Site Survey of Selected Items
for
Compliance with the Americans with Disabilities Act
(ADAAG)
and
Title 24 of the CBC

The site survey of 3rd Street Elementary School was conducted on March 1, 2007 during a spot check for compliance with the Americans with Disabilities Act Guidelines (ADAAG)
and
Title 24 of the CBC

Facility Name: 3rd Street Elementary School

Boys Restroom Next to Room 16

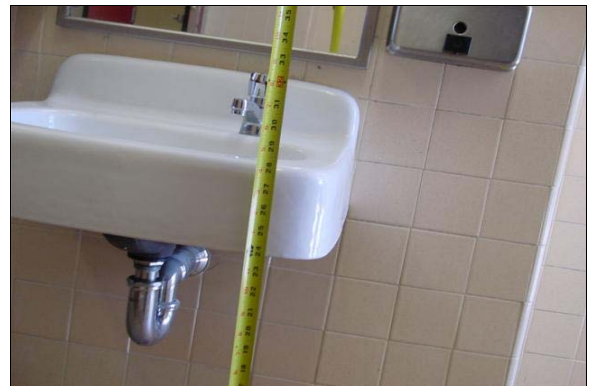
Finding: The flush control on the toilet interferes with the use of the back grab bar.

Full Rec Remount the back grab bar in the stall designated to be accessible in the restroom so that the height of the gripping surface is centered at 33 inches above finished floor. Grab bars must be able to support a point load of at least 250 pounds and shall be less than the allowable shear stress of the grab bar material.

Girls Restroom Next to Room 16

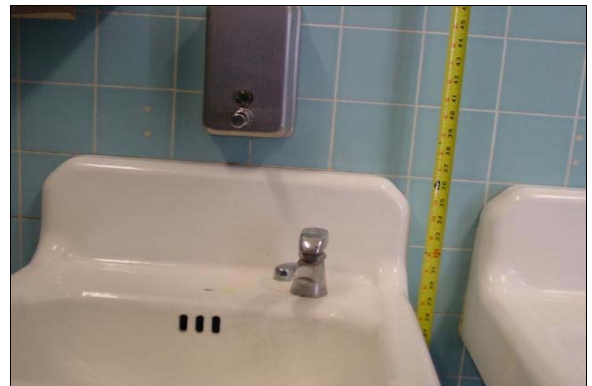
Finding: The height of the controls and operating mechanisms for the soap dispenser in the restroom is 38 inches above the finished floor for restrooms used primarily by children.

Full Rec Relocate the soap dispenser in the restroom to a maximum height of 36 inches above the finished floor for all the controls and operating mechanisms to accommodate children ages 5 thru 12 (see CBC 1115B.9.2).

Womens Restroom in Auditorium

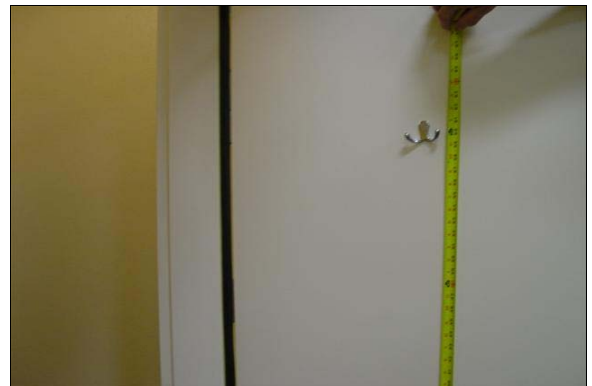
Finding: The height of the coat hook is 60 inches above the finished floor.

Full Rec Relocate the coat hook to a height no greater than 48 inches above the finished floor.
